Re: **COVID 19 Reopening Guidance – Facilities Clarifications**

**Office of Facilities Planning, New York State Education Department August 17, 2020
COVID-19 Reopening Guidance – Facilities Issues Clarifications**

4. **FAQ No.11 (Revised)**

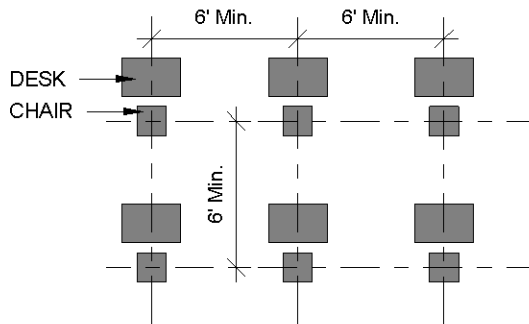
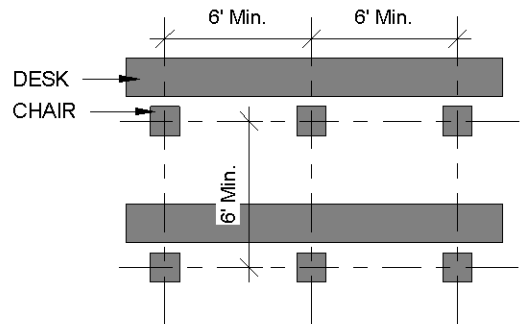
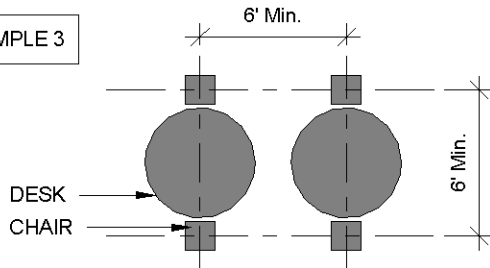
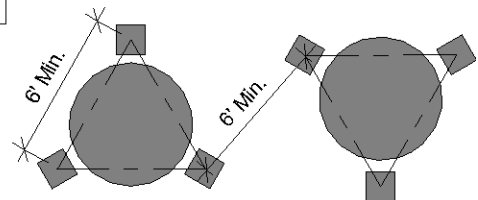
Where do we take measurements from to establish social distancing; for example in the layout of furniture/equipment/etc.?

To achieve acceptable social distancing between the occupants of classroom desks, chairs and teaching consoles, establish a minimum of 6' separation measured to the centerline of individual's space. Measurements should be taken in a manner consistent with the example diagrams below.
